To: [Department of Planning, Industry and Environment](#)
Produced: Michele Zornitta (Associate Water Resources Engineer -WSP)
Reviewed: John Pickering (Associate Engineer - WSP)
Subject: **Waterloo Metro Quarter OSD**
SSD-10440 Northern Precinct – Response to submission comments
Date: 15 February 2021

This note has been prepared to respond to the comments dated 25 November 2020 raised by the Environment, Energy and Science Group (EES) to the Department of Planning, Industry and Environment (DPIE) public exhibition period for Waterloo Metro Quarter Over Station Development (OSD).

Specifically, this note responds to the comments for the Northern Precinct detailed SSD DA (SSD-10440). Figure 1 below represents a schematisation of Waterloo Metro Quarter OSD - areas in purple identify the proposed Northern Precinct (SSD-10440).

Figure 1: Waterloo Metro Quarter site, with sub-precincts identified

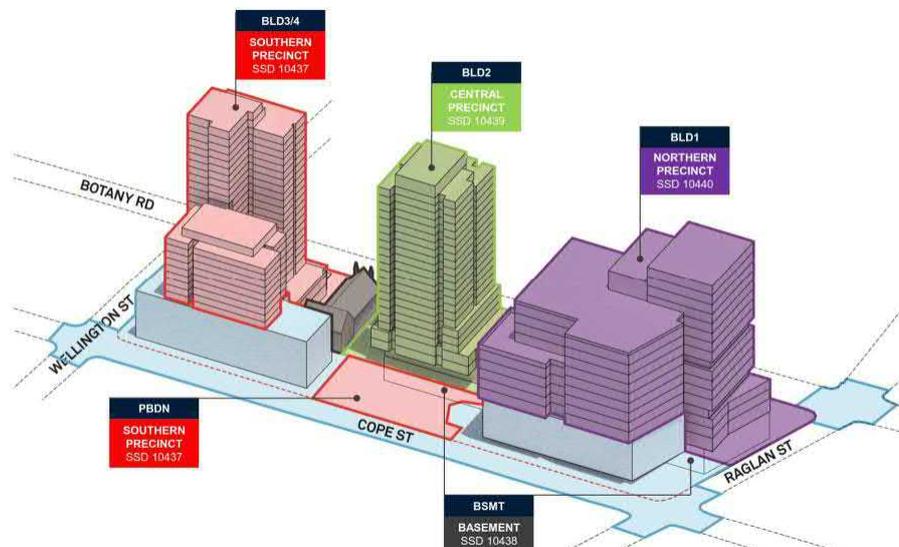
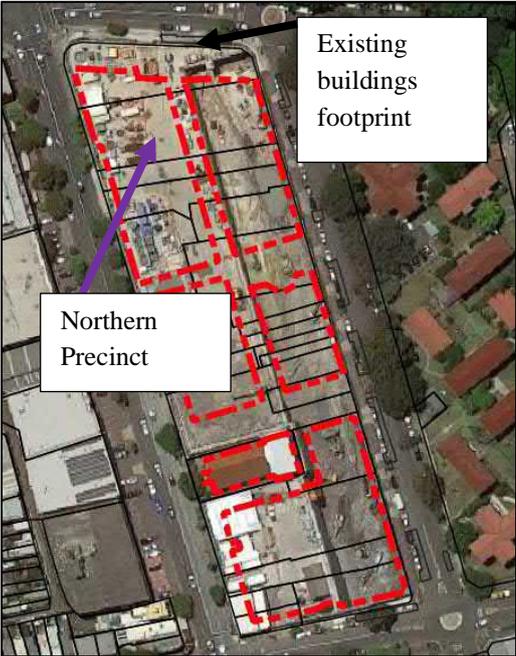
Flood impacts of the proposed development	
<p>2 The individual buildings of the over station development are not expected to cause any flood impacts; however, the ancillary road works are predicted to cause unacceptable impacts.</p>	<p>As noted by the EES reviewer the individual buildings of the OSD are not expected to cause any negative flood impacts.</p> <p>This is due to the footprint occupied by the proposed buildings and Cope Street plaza that is less than the existing buildings as shown in figure below.</p>

<p>Existing buildings footprint</p> <p>Northern Precinct</p> <p>Northern Precinct development (SSD-10440) do not affect topography levels outside the existing buildings footprint (i.e. pre-development conditions prior to any work associated with the metro station construction).</p> <p>As such, it is not possible for the Northern Precinct to negatively affect flood conditions to the adjacent land because the building footprint is less than the pre-development footprint.</p>
3	<p>The report notes that the Council of the City of Sydney was consulted and noted that an acceptable tolerance for flood level increase would be 10mm. This is considered reasonable and within the level of accuracy of current best practice flood modelling. The Concept Water Quality, Flooding and Stormwater Report of 2018 showed flood level increases that were within the limit of 10mm. It appears that road works were not included in the concept stage modelling.</p>	<p>Noted.</p> <p>As indicated in response 2 the northern precinct is not expected to generate flood impacts. We advise that further consultations on flood impacts (i.e. in September and October 2020) have been held with the CoS as part of the metro station Critical State Significant Infrastructure (CSSI) application. We anticipate that CoS would accept the flood impact generated by metro station Critical State Significant Infrastructure (CSSI) application; this has not yet been issued by CoS.</p>

Waterloo - OSD
 Proposed Scenario - 1% AEP
 Water Level

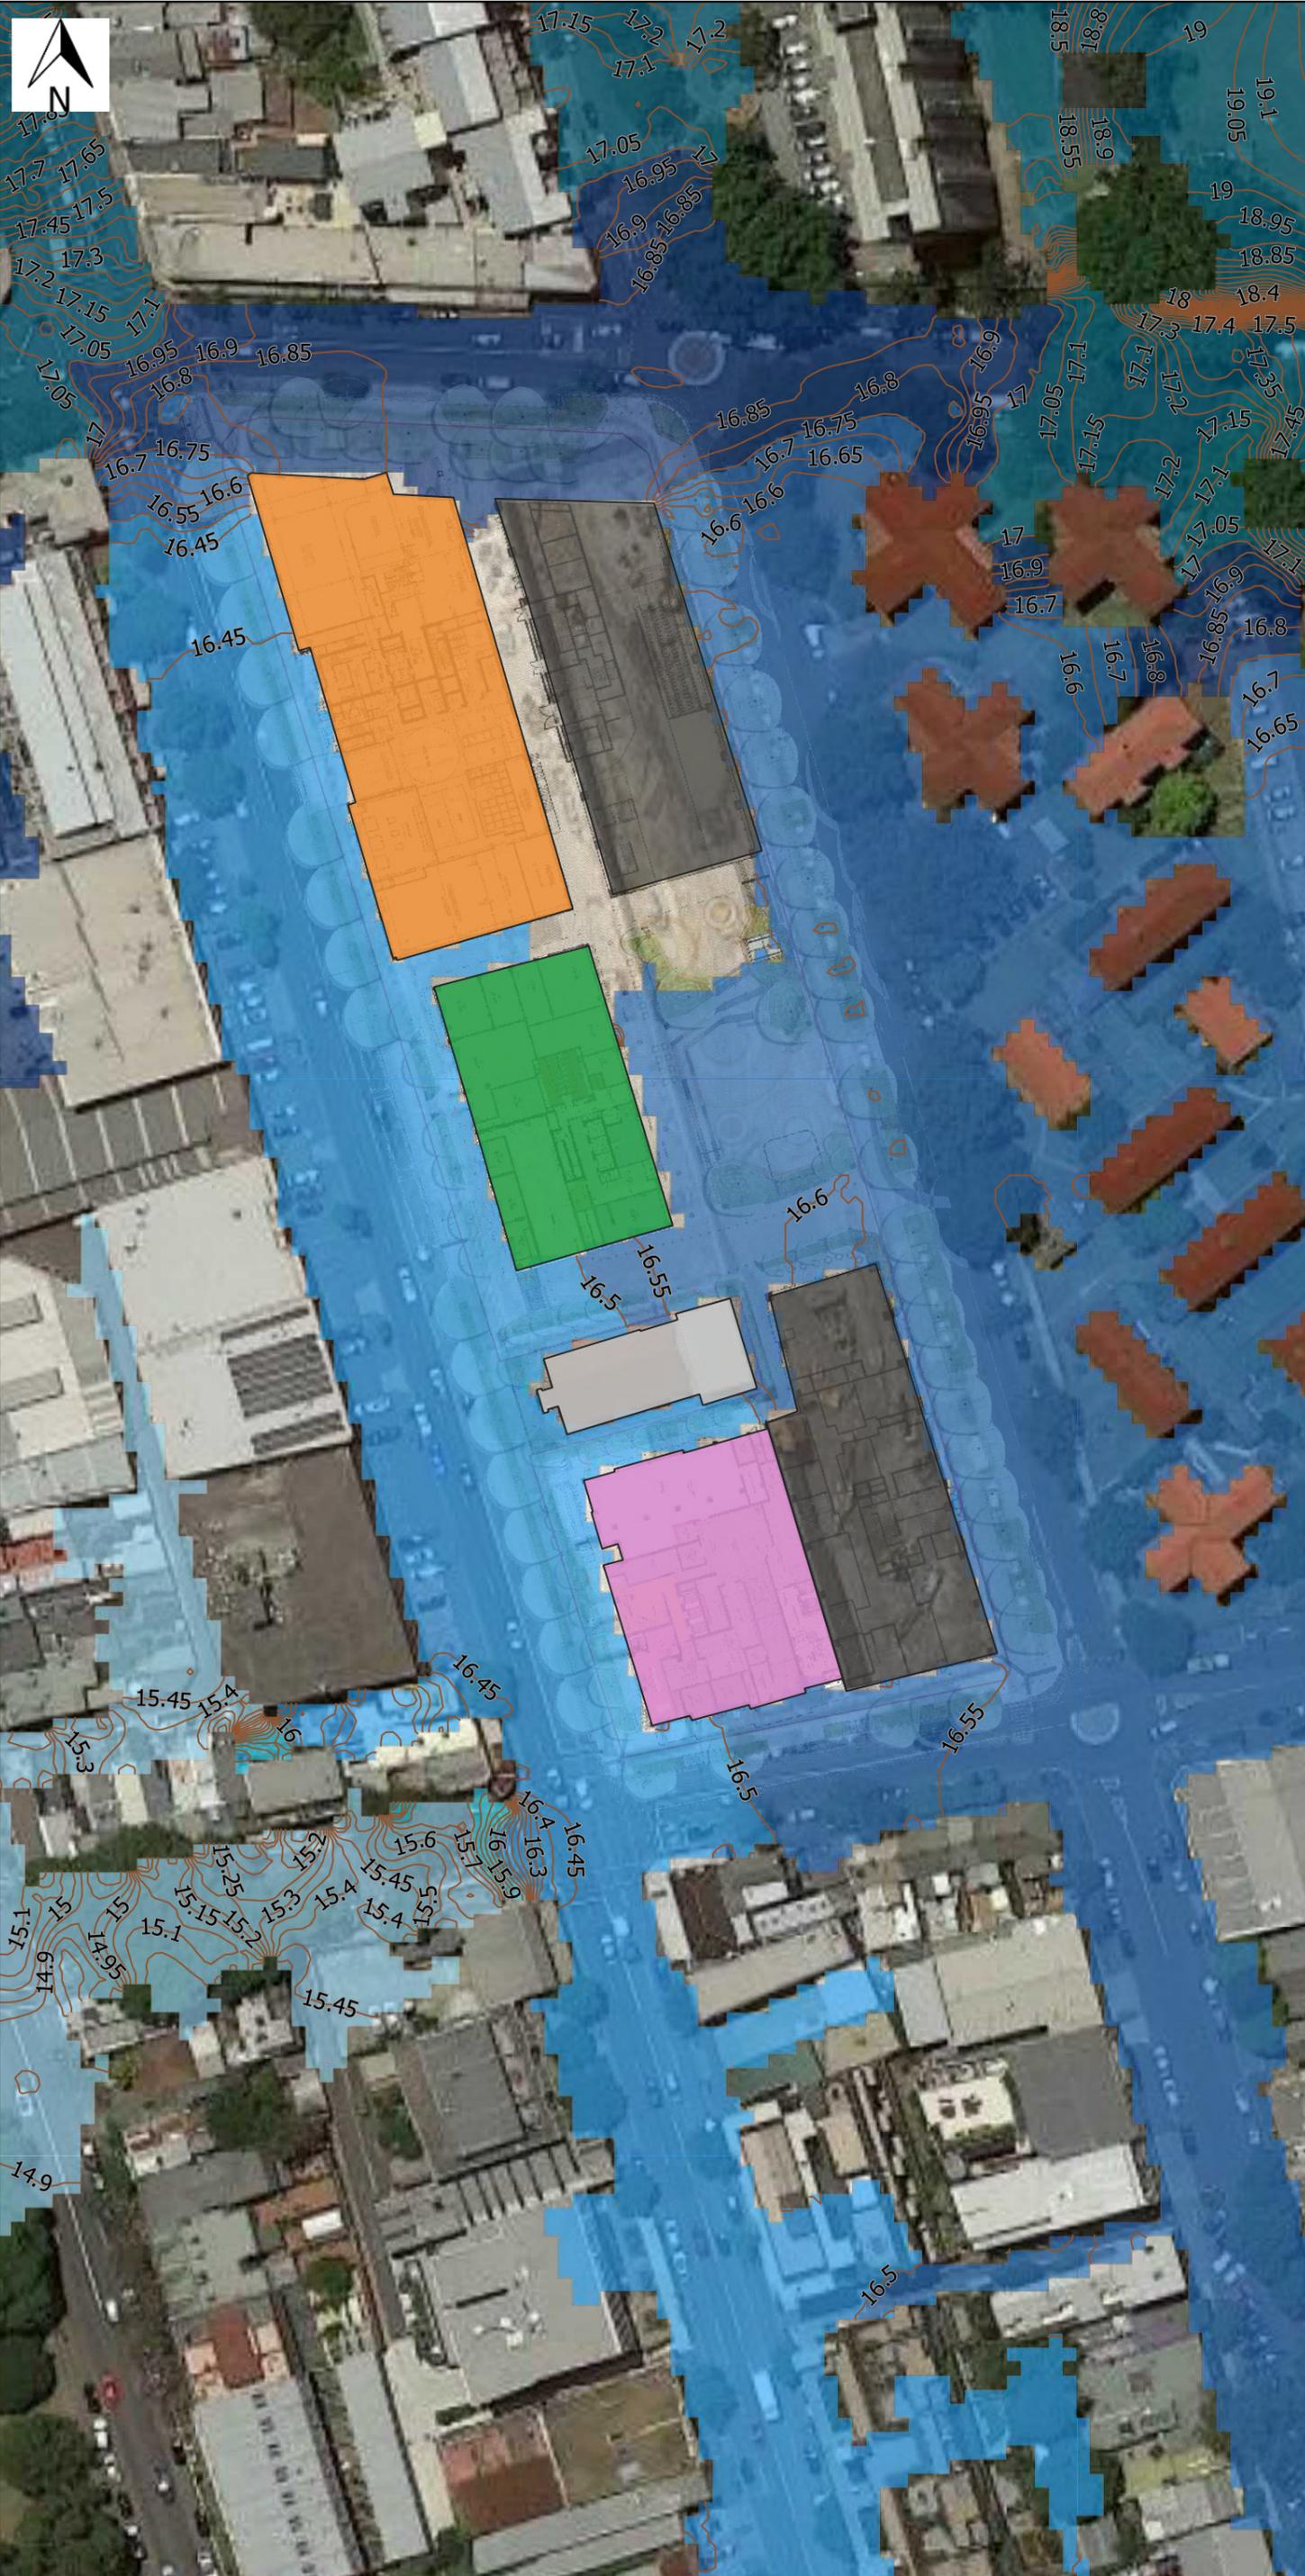
Comment	Response
Floodplain risk management	
<p>1 The reports have not included flood level mapping for any scenarios, except the 1% AEP flood event plus climate change. This is a significant omission. This mapping, including water level contours at appropriate intervals, must be provided as a minimum for the 5% and 1% AEP flood events and the PMF event. It is not possible to verify any of the flood level information quoted in the report without this mapping. A proper review of the submission cannot be completed until this has been provided.</p> <p>The frequency of typographical and grammatical errors does not give the reader any confidence that the appropriate degree of checking and verification has been completed in general.</p>	<p>Maximum flood levels for the 1%AEP, 1% AEP + Climate Change (CC) and PMF flood events are included in <i>Table 4: Design flood planning levels – Building Floor Levels of the Stormwater Management Strategy and Flood Impact Assessment – SSD-10440 Northern Precinct report</i>; flood levels included in Table 4 represent the maximum water levels for the 1%AEP, 1% AEP+CC and PMF flood events in correspondence to relevant building areas.</p> <p>Table 4 is now superseded by table included in Appendix B of this response.</p> <p>Flood levels for the 5% AEP flood event was not originally included in the flood impact assessment report as not relevant in the determination of flood planning levels; flood planning levels have been informed by the 1% AEP, 1% AEP+CC and PMF maximum flood levels.</p> <p>Water level contour maps (with a 50mm contour interval) for the 5%AEP, 1% AEP and PMF flood events have been prepared and attached to this response as requested by the EES reviewer (Appendix A).</p> <p>The report and technical work developed for Waterloo Metro Quarter OSD has been reviewed and approved by the appropriate WSP flood engineers; the Flood Impact Assessment report has also been reviewed and approved by Waterloo OSD representatives.</p>

Sheet title
 SSD10440
 BUILDING 1 - FLOOR PLAN - LEVEL GROUND

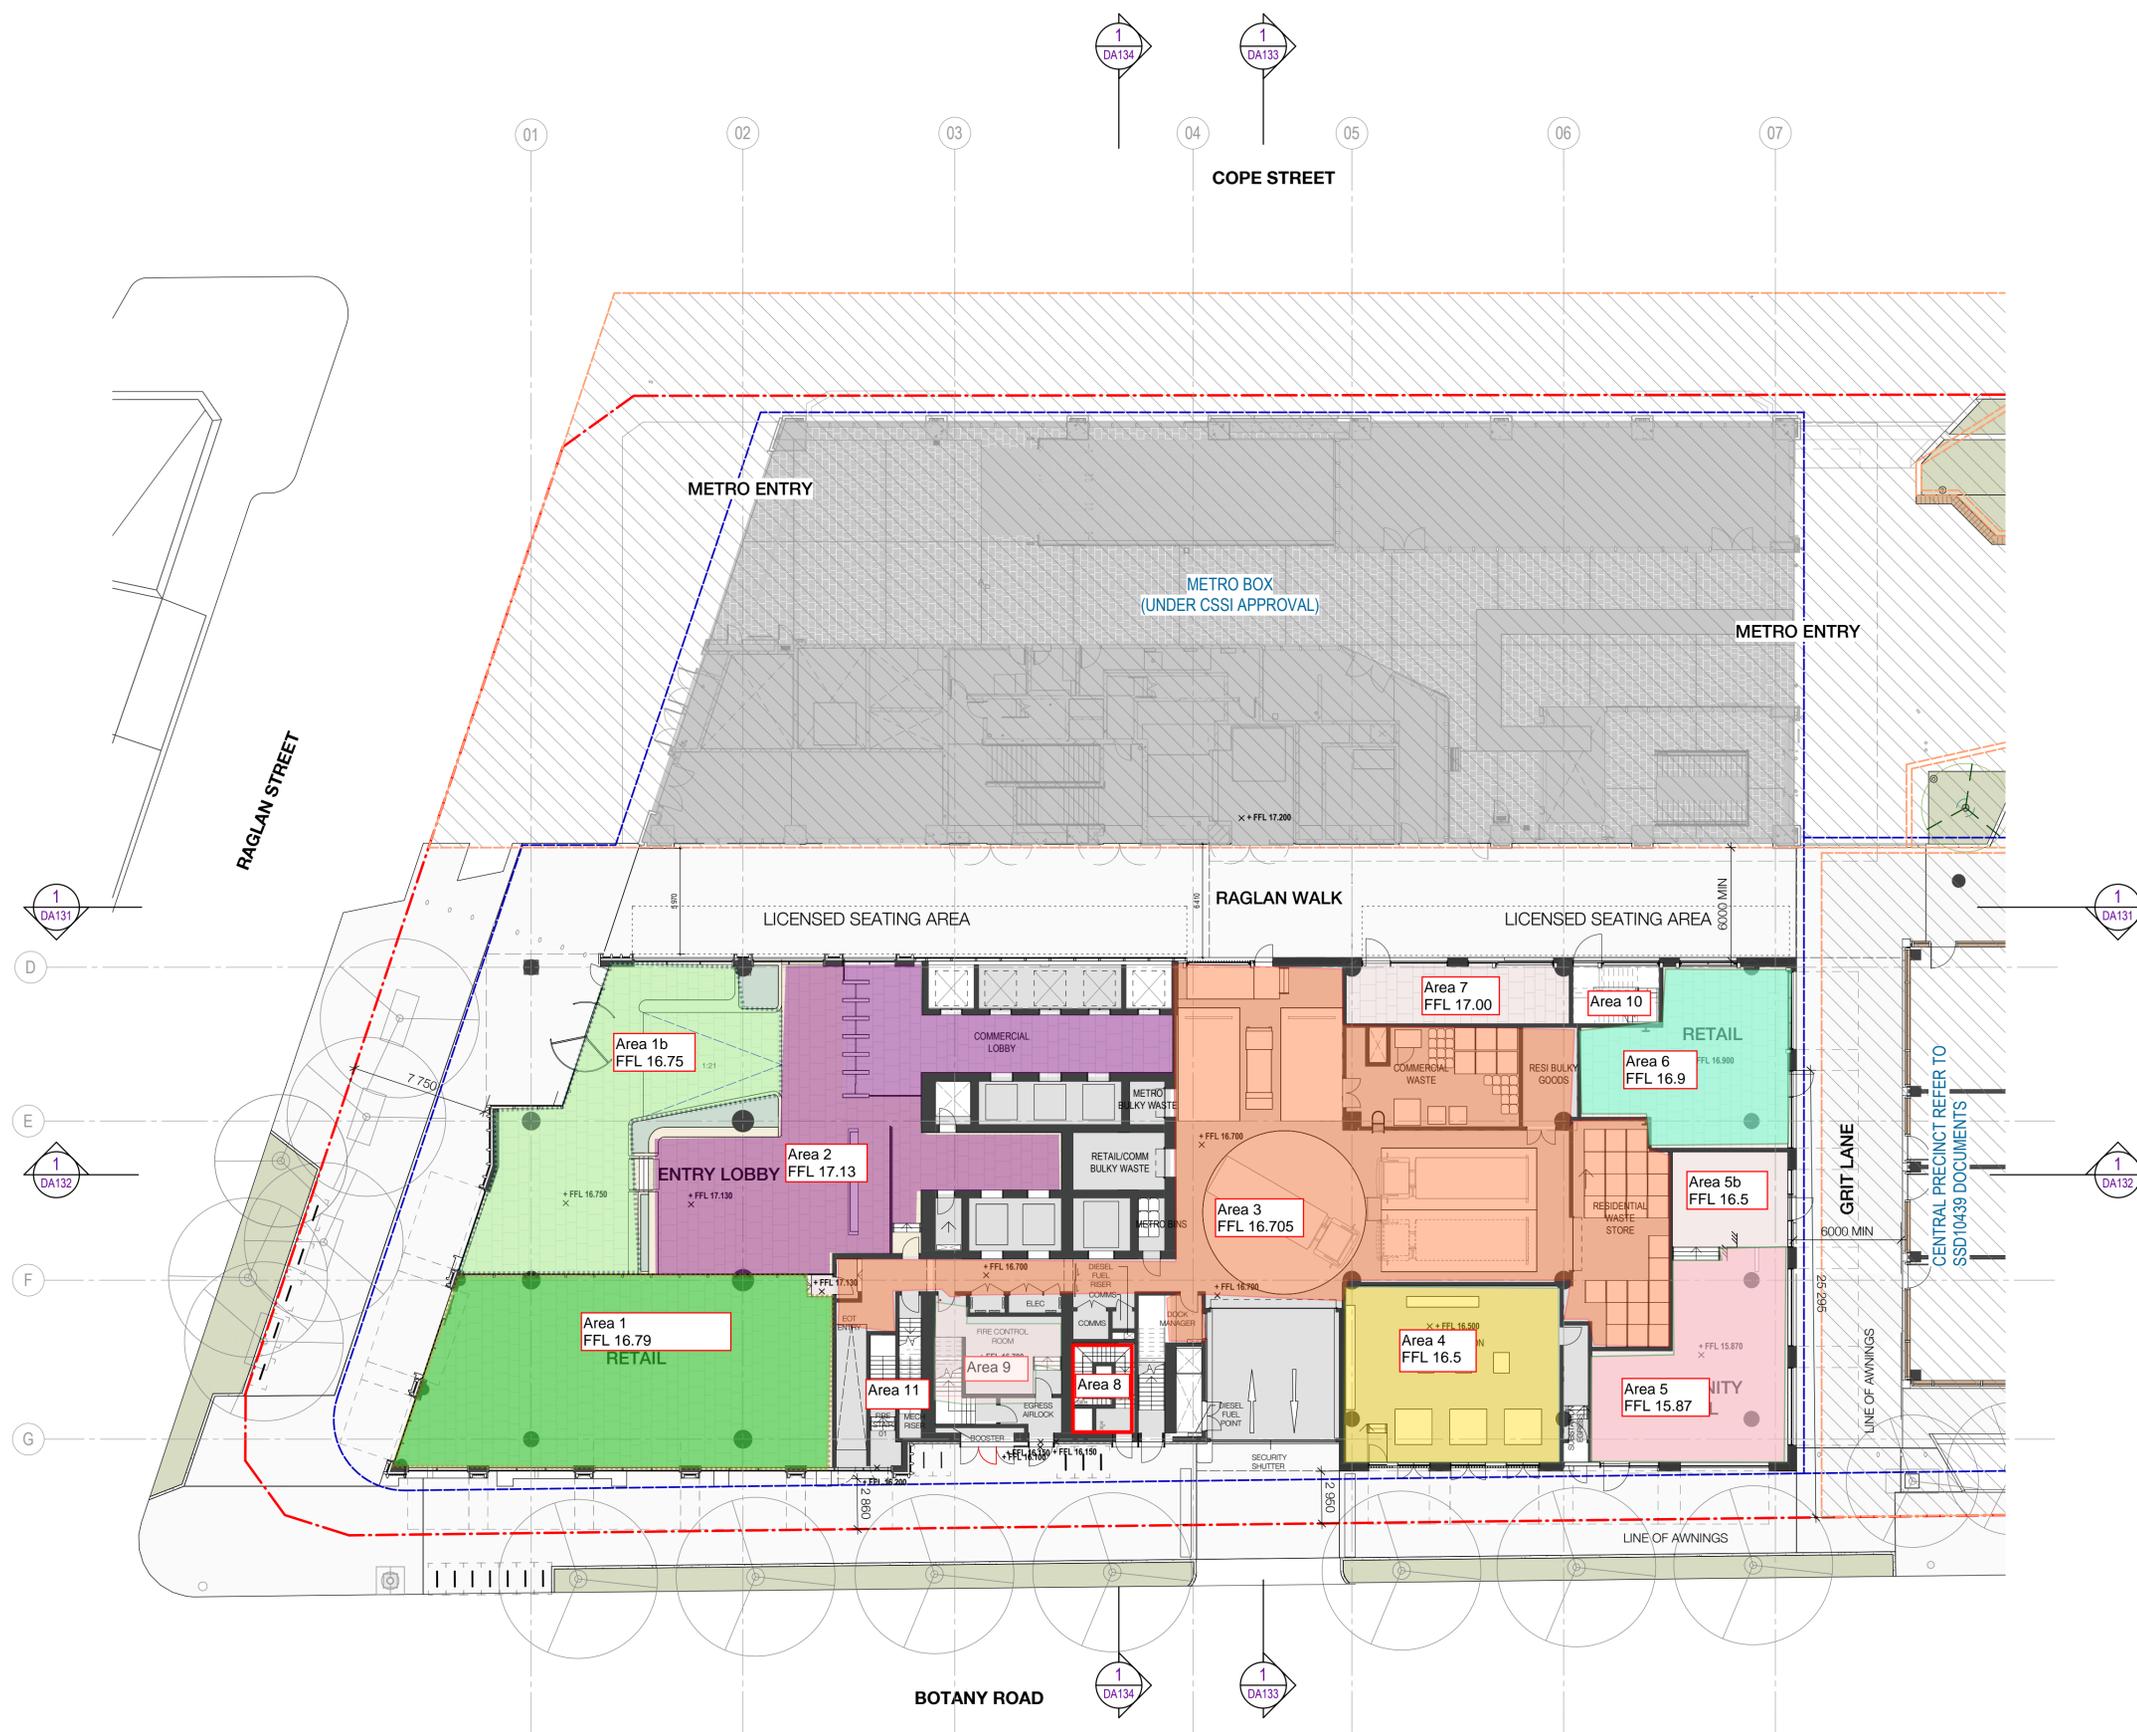
6	<p>It appears that all the floor levels meet the requirements. Generally, floor levels are above the 1% AEP flood level and generally above the PMF level. Where required at entries to basements, 500 mm freeboard to the 1% AEP flood level appears to have been provided.</p>	<p>Noted.</p> <p>We confirm that project requirements are met.</p>
7	<p>However, the report has not adequately documented all the proposed finished floor levels (FFLs) to enable their comparison to the proposed FPLs. As a minimum, the FFLs need to be provided in Table 4 alongside the FPLs. A possible source of confusion is that the column in the table titled FPL may in fact be FFL. In any case, the FPL should be clearly stated, alongside the FFL. Area 10 FFLs are not visible on the plan provided at Appendix 15.</p>	<p>Refer to Appendix B (Building Floor Levels) for the updated FFLs and FPLs.</p> <p>We advise that building layout has been updated since the last submission.</p>

7	<p>It appears that there are discrepancies and errors in report e.g. the 1% AEP plus climate change flood at Area 10 is quoted as 0.5m higher than the 1% AEP flood level without climate change, which is vastly inconsistent with the other levels and would require careful reconsideration of FPL level and FFL if that is the case. Consequently, it is recommended that all the flood levels should be checked to ensure no further errors are present</p>	<p>FFLs and flood levels have been updated as indicated in Appendix B.</p>
<p>Flood risk for the development – Residual Risk and Emergency Management</p>		
9	<p>While it has been asserted, that “Safe refuge can be provided within the proposed development”, this has not been demonstrated. There are several issues regarding residual risk that have not been addressed and require amendments to the design. It is recommended that the proponent engage a suitably qualified and experienced professional to develop an appropriate strategy for flood emergency management. The Alexandra Canal Floodplain Risk Management Study and Plan should be considered along with all relevant emergency management documents by the SES.</p>	<p>It is considered that proposed finished floor levels for the Northern Precinct provide adequate flood protection in case of a flood emergency.</p> <p>Area 1 (retail area): proposed floor level is at 16.790 m AHD which is 176 mm above the 1%AEP flood level.</p> <p>In an extreme flood event (i.e. PMF) water depth in Area 1 would be 2 cm. Thus, flood risk is considered low. Although evacuation from Area 1 is not considered necessary, occupants of Area 1 can internally access Area 2 which has a floor level above PMF and the 1%AEP+500mm freeboard flood event.</p> <p>Area 1b (lobby): Area 1b is not affected by flooding in the 1%AEP and 1%AEP+CC flood events. Proposed floor level is at 16.75 m AHD which is 7 cm below the PMF flood level.</p>

<p>Occupants of Area 1b can access Area 2 which has a floor level above the PMF and 1%AEP+500 mm freeboard flood event.</p> <p>Area 2 (lobby): proposed floor level for area 2 is above PMF and 1%AEP+500 mm freeboard flood event. Thus, no evacuation is necessary for occupants of Area 2 in case of a flood emergency.</p> <p>Area 3 (loading dock): proposed floor level for area 3 is above the PMF flood level. Thus, no evacuation is necessary for occupants of area 3 in case of a flood emergency.</p> <p>Area 4 (substation): proposed floor level for Area 4 is above PMF flood level. No evacuation is necessary for occupants of area 4 in case of a flood emergency.</p> <p>Area 5 and 5b (community area): proposed floor level for area 5 is above the 1%AEP flood level. Proposed floor level for area 5b is above the PMF flood level. Occupants of Area 5 can access area 5b (within the building) in case of a flood emergency. Area 5b can be used as shelter.</p> <p>Area 6 (retail area) proposed floor level for area 6 is above the PMF flood level. Thus, no evacuation is necessary for occupants of area 6 in case of a flood emergency.</p> <p>Area 7 (retail area): area 7 is not affected by flooding up to and including the PMF flood event. Proposed floor level for area 7 is above the nearest PMF flood level. Thus, no evacuation is necessary for occupants of area 7 in case of a flood emergency.</p> <p>Area 8 (egress from basement): egress level is proposed above PMF and 100 ARI+ 500 mm to protect the basement from flooding.</p> <p>Area 9 (fire control room): proposed floor level is above PMF. Occupants of area 9 can easily access Area 3 (above PMF flood level)</p>
